**Fo81J, Fo81K, Fo81S; Fo8L9
BCTS Foghorn VIA
prepared by
RDI Resource Design Inc
November 7, 2015**

VNS Simulation of Landforms and Visual Sensitivity Units

Raft original without RDI Leave. Existing nonVEG in orange.

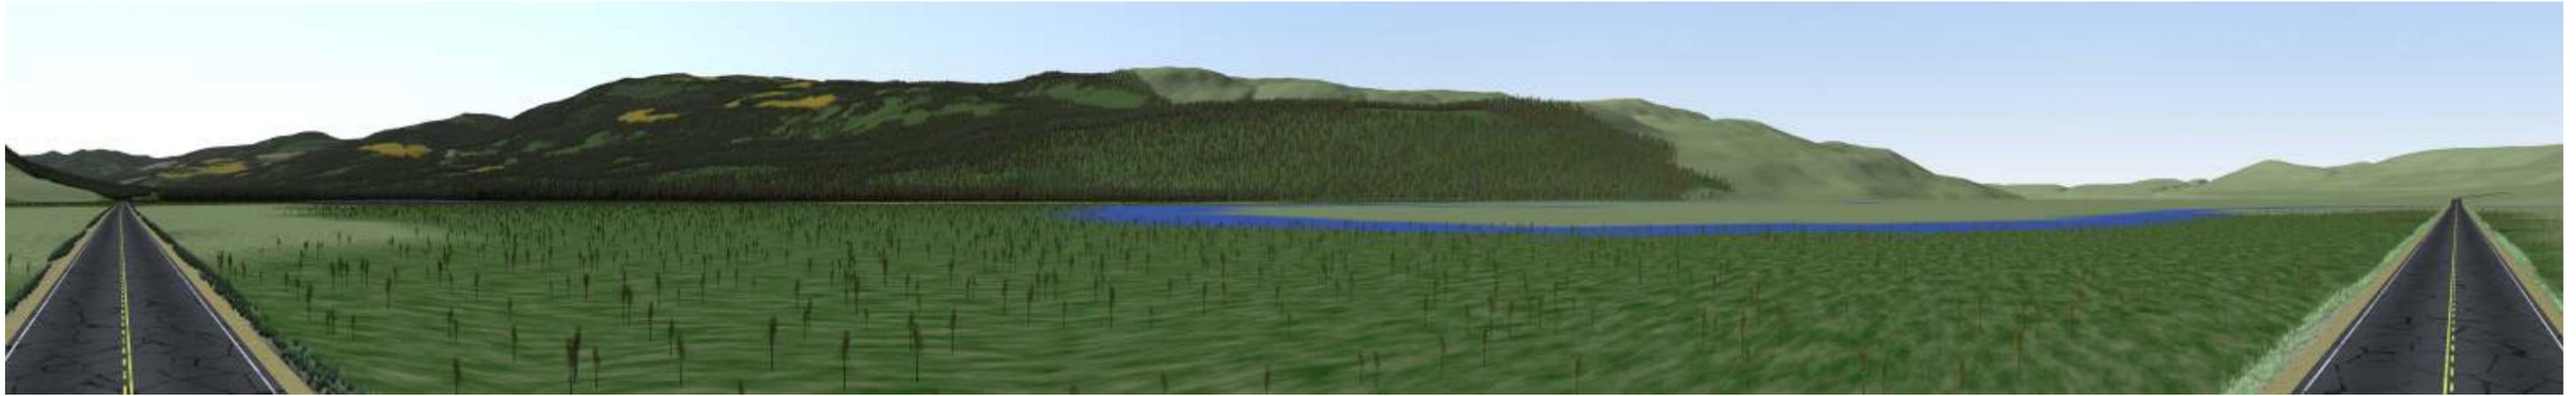
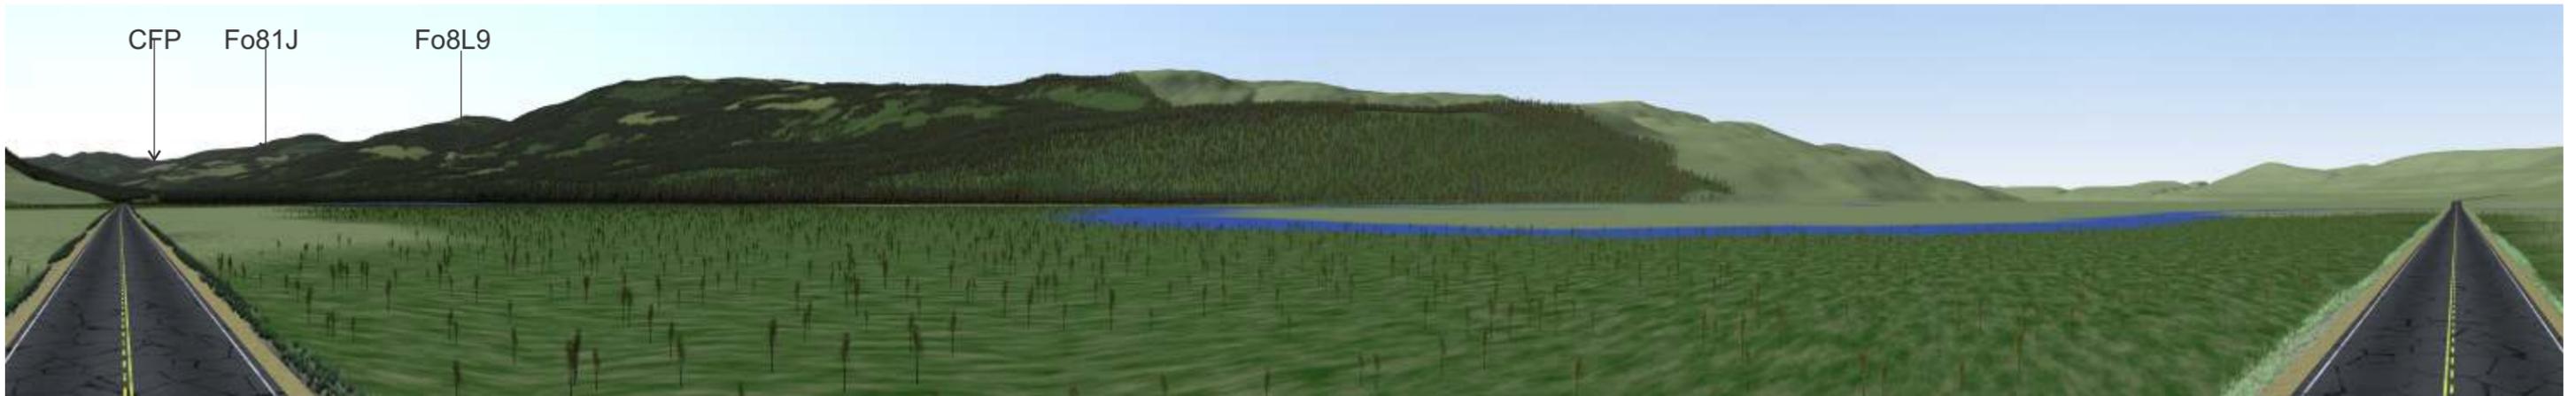
Fo81J- reduced angularity
Window in to view the distinctions between the two scenarios for Fo81J.
No Percent Alteration prepared for Landform 4 due small size of Fo8L9.
